Mecklenburg County
Health Department

Re: Application for improvement permit for Howard Baucom
Property Site: 11225 Texland Blvd.
Health Department file no. 5052B

SOIL/SITE EVALUATION
for ON-SITE WASTEWATER SYSTEM

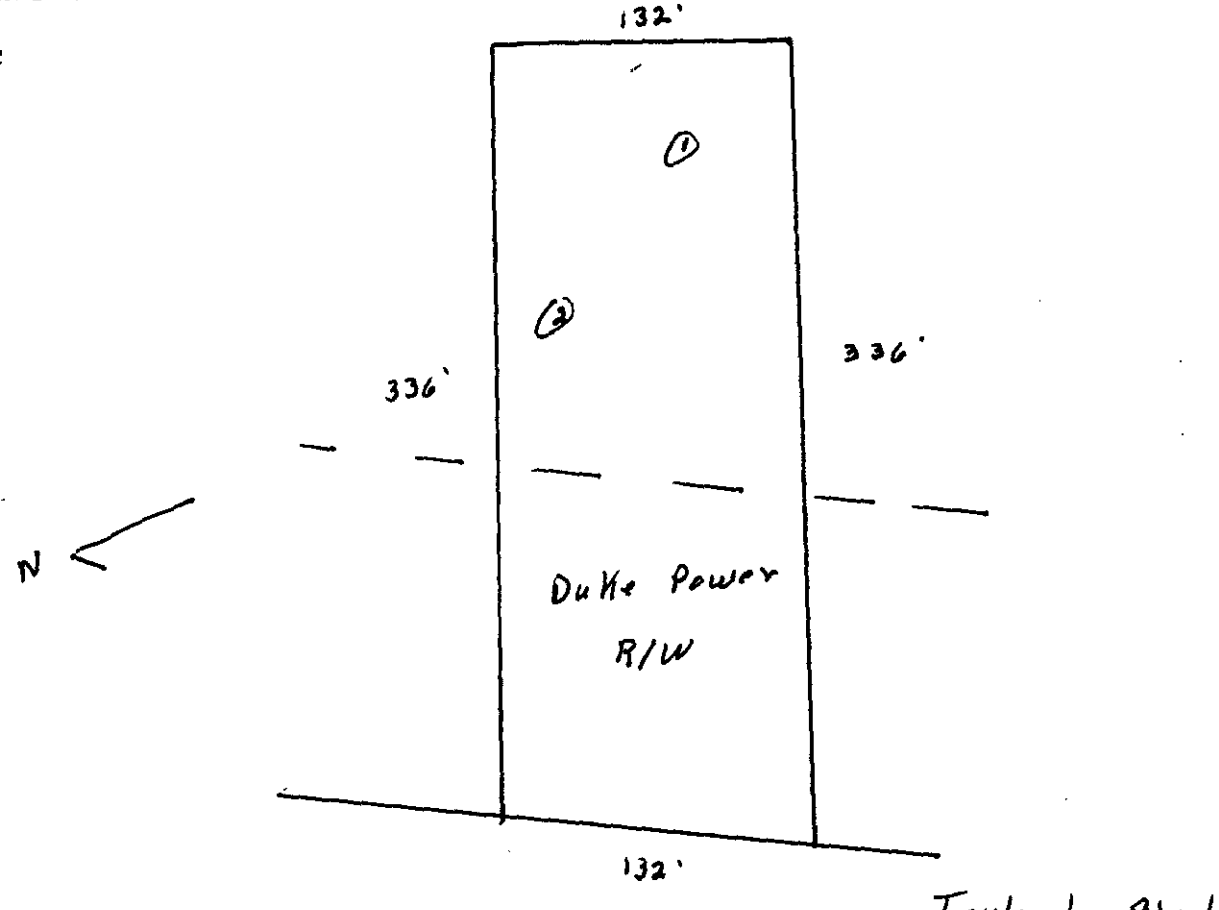
PROFILE #	.1940 Landscape Position/ Slope%	Horizon Depth (IN.)	SOIL MORPHOLOGY .1941 .1941 Structure/ Texture	.1941 Consistence Mineralogy	OTHER PROFILE FACTORS .1942 Soil Wetness/ Color	.1943 Soil Depth (IN.)	.1956 Sapro Class	.1944 Restr Horiz	Profile Class & LTAR
1	LS, 8	0-8	GR/SCL	FR/SEXP/SS/SP	>37" TO SOIL WETNESS	37	N/A	NONE	US
		8-37	ABK/C	VFI/EXP/VS/VP					
2	LS, 6	0-7	GR/SCL	FR/SEXP/SS/SP	>22" TO SOIL WETNESS	22	"	"	"
		7-22	ABK/C	VFI/EXP/VS/VP

Other Factors (.1946): _____
Site Classification (.1948): UNSUITABLE
Evaluated By: W. R. Marlin, LSS, 9/3/02, W. R. Marlin
Others Present:
